**Submission from the Maules Creek
Community Council**

Boggabri Coal Modification 10

11.7.2025

Groundwater Impact Assessment Concerns

Evaluation and Redesign of the Conceptual Environmental Model – Greenhouse Gas Assessment

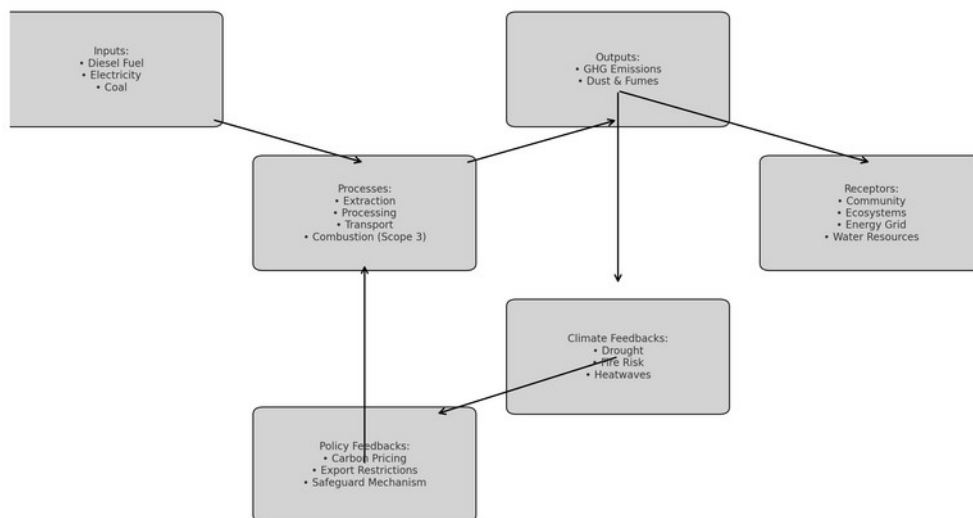
The conceptual environmental model (CEM) used for the greenhouse gas assessment lacks depth. It frames GHG emissions as a linear output from project inputs with little recognition of feedback mechanisms or external risks. There is no systems-level diagram or scenario planning. Climate change, energy policy shifts, or socio-political responses are not integrated (Appendix E, p. 36; source not specified).

- Include system boundaries for Scope 1, 2, and 3 emissions
 - Incorporate dynamic variables (e.g. rainfall variability affecting dust control, energy usage)
 - Model cumulative emissions from adjacent mines (e.g. Maules Creek, Tarrawonga)
 - Integrate feedback loops between emissions, policy (carbon pricing, Safeguard Mechanism), and regional climate impacts (e.g. fire, drought)
 - Reflect risks to community and infrastructure via receptor pathways
 - Include adaptation and mitigation response pathways and decarbonisation scenarios
-

Evaluation and Redesign of the Conceptual Environmental Model – Greenhouse Gas Assessment

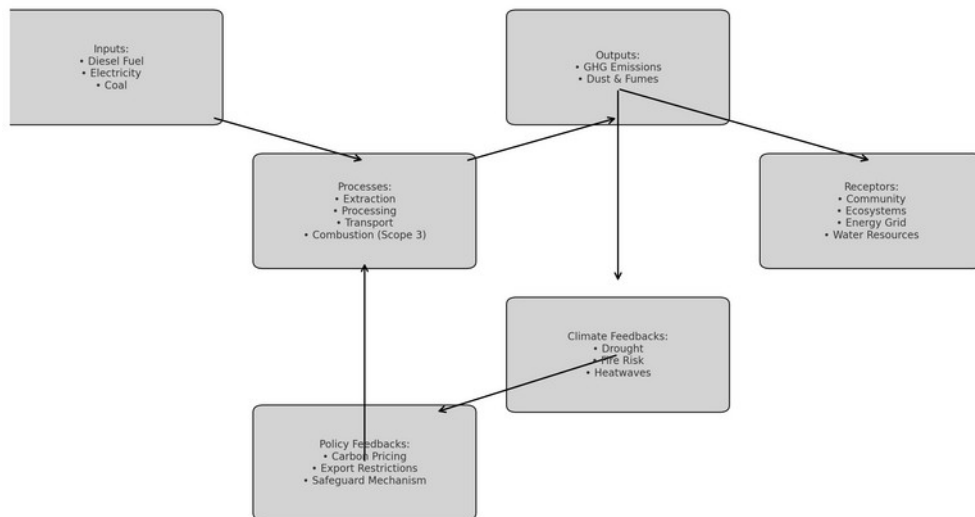
The conceptual environmental model (CEM) used for the greenhouse gas assessment lacks depth. It frames GHG emissions as a linear output from project inputs with little recognition of feedback mechanisms or external risks. There is no systems-level diagram or scenario planning. Climate change, energy policy shifts, or socio-political responses are not integrated (Appendix E, p. 36; source not specified).

- Include system boundaries for Scope 1, 2, and 3 emissions
 - Incorporate dynamic variables (e.g. rainfall variability affecting dust control, energy usage)
 - Model cumulative emissions from adjacent mines (e.g. Maules Creek, Tarrawonga)
 - Integrate feedback loops between emissions, policy (carbon pricing, Safeguard Mechanism), and regional climate impacts (e.g. fire, drought)
 - Reflect risks to community and infrastructure via receptor pathways
 - Include adaptation and mitigation response pathways and decarbonisation scenarios
-

Evaluation of Conceptual Environmental Model – Appendix F

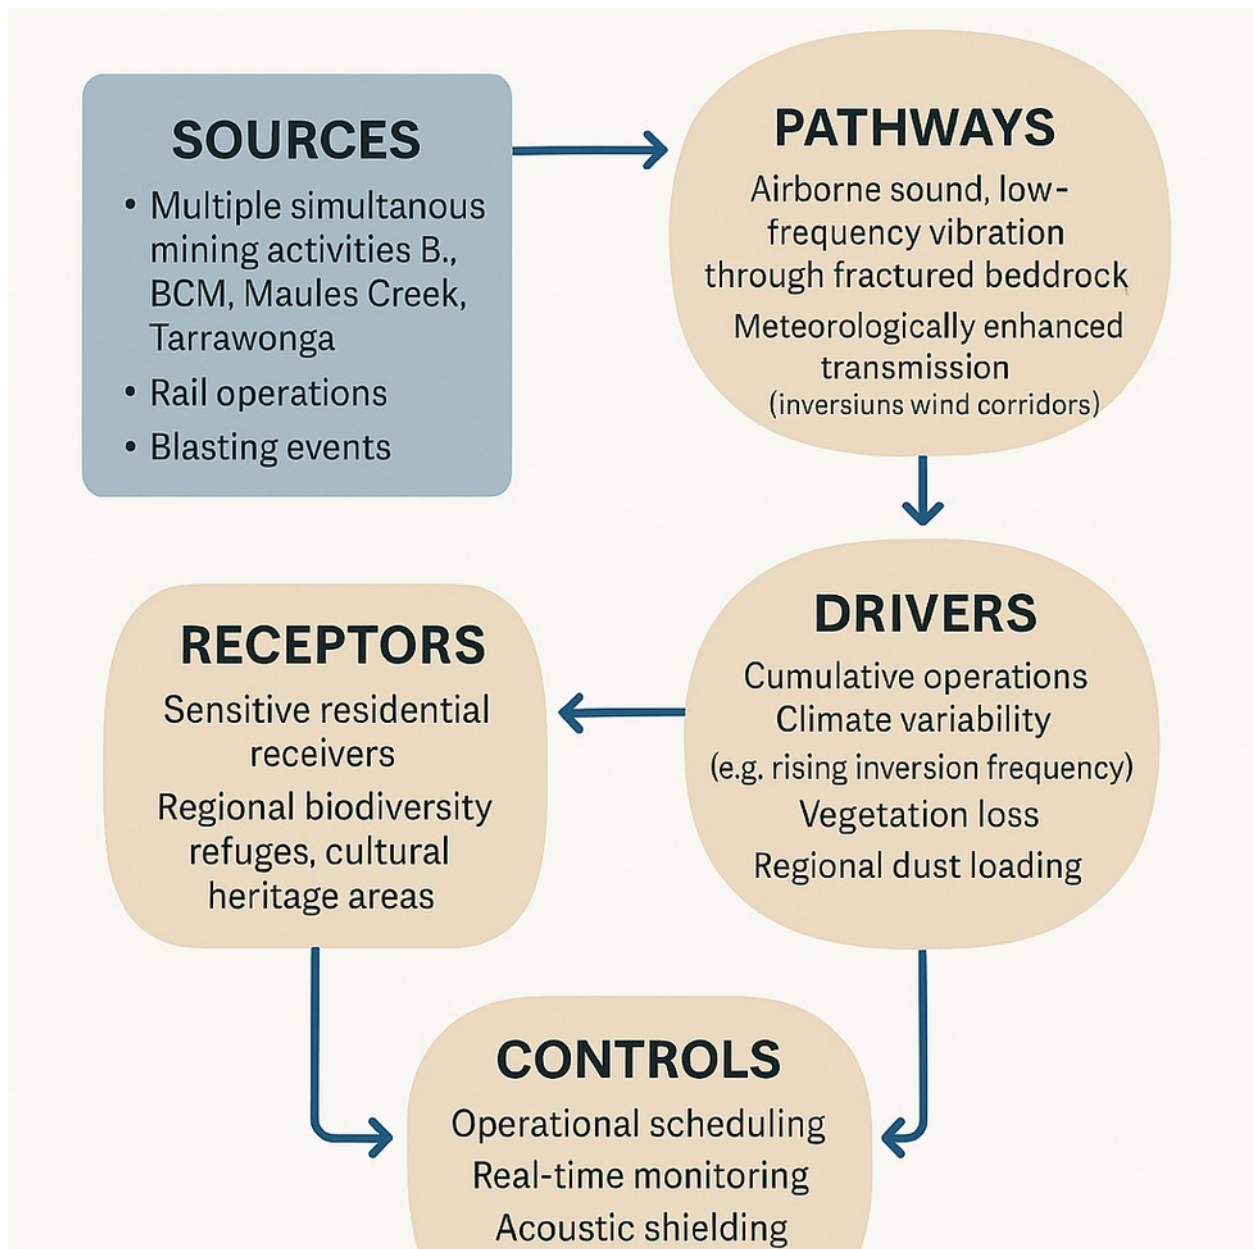
The existing model is linear, source-to-receptor. It omits cumulative stressors, ecological feedbacks, and does not link meteorological drivers (e.g., inversions) to acoustic effects (Appendix F, pp. 14–20).

Conclusion: The model is narrowly scoped and reductionist.
